Steel Framed Building
at
Rotherham, S63 9BL
for
Hanson Buildings Limited

Roof Plan

SCN3068 02 C

Roof Plan

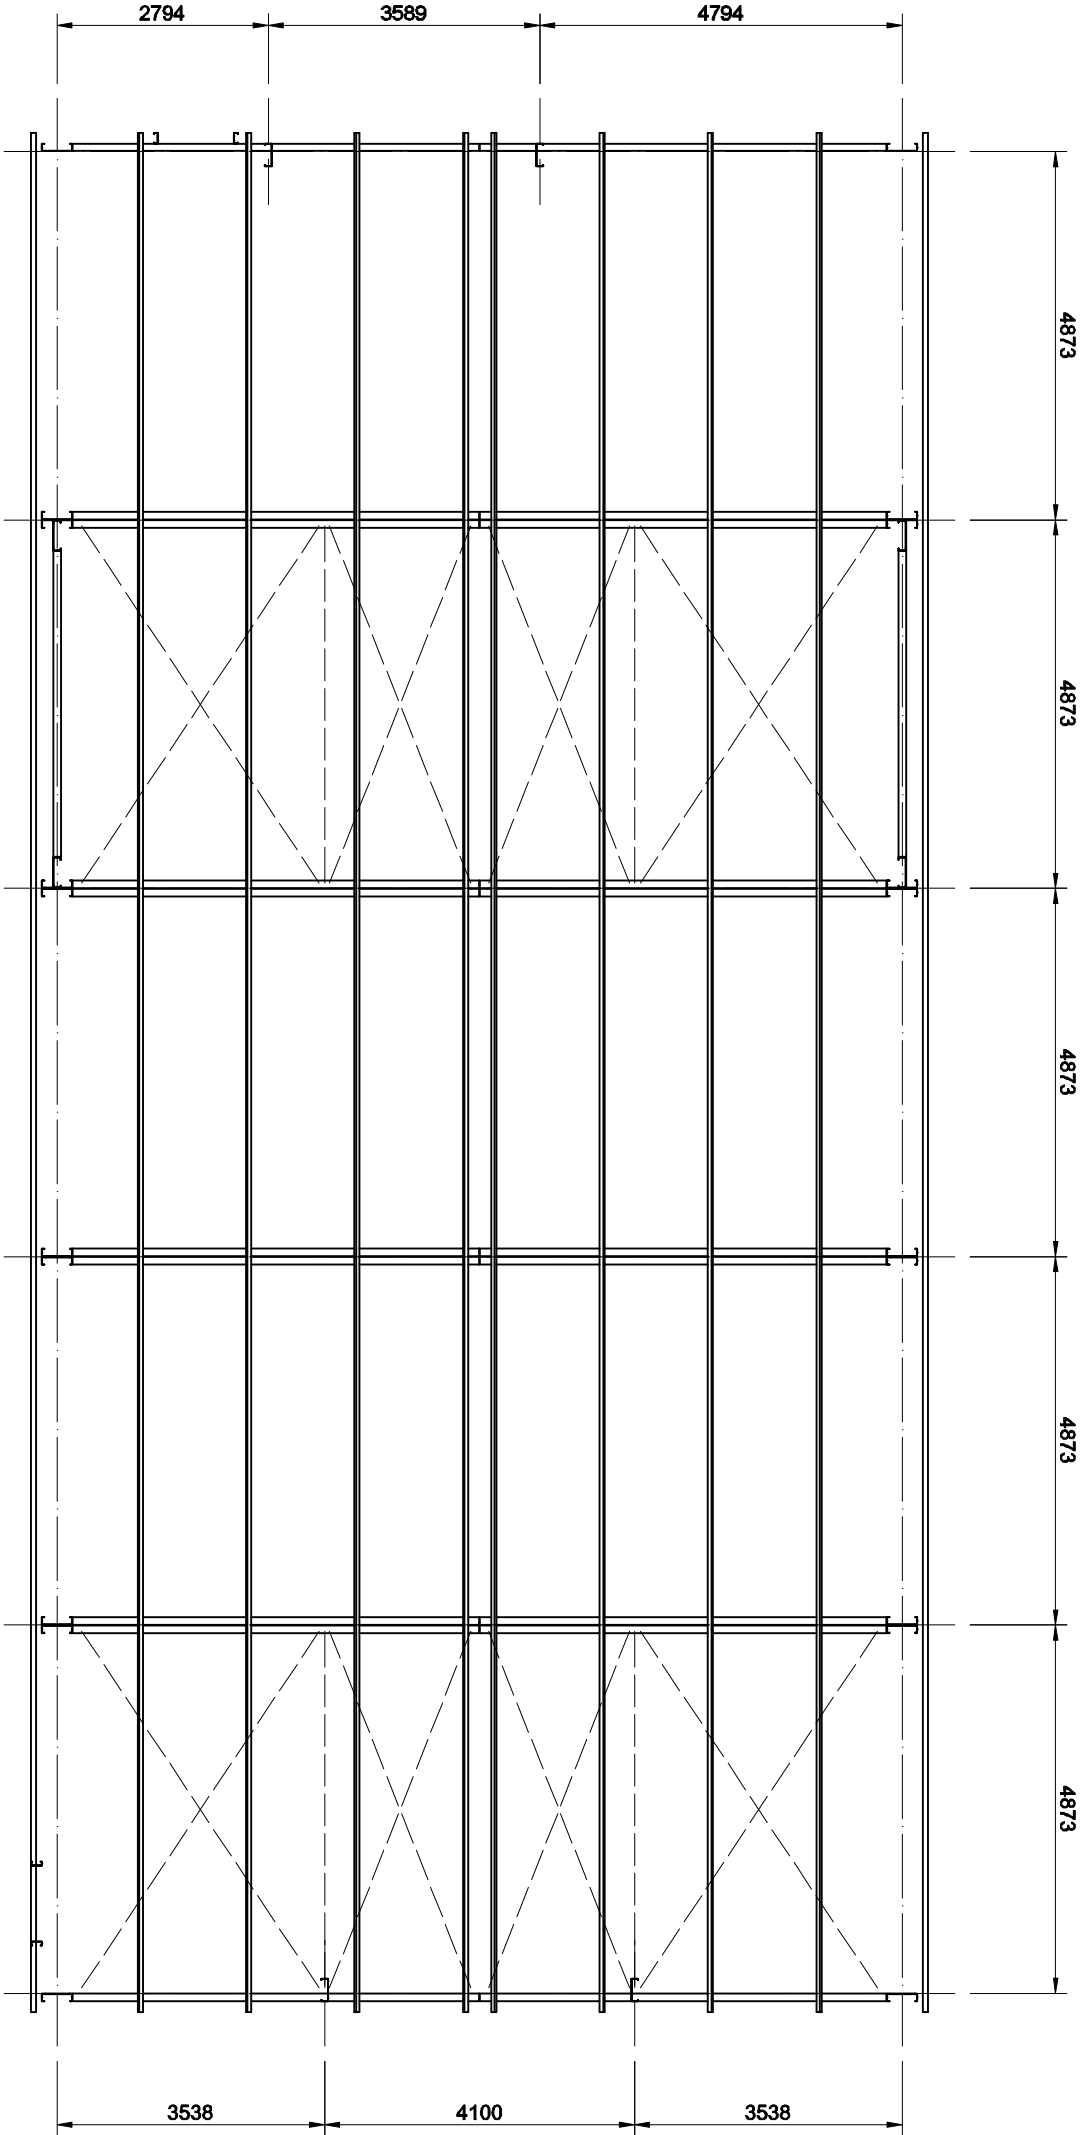
- Rev C Revised to add windows and windpost frame to rear elevation. 02/07/26
- Rev B Revised building design and door locations. Also Windows and windpost added. 28/04/26
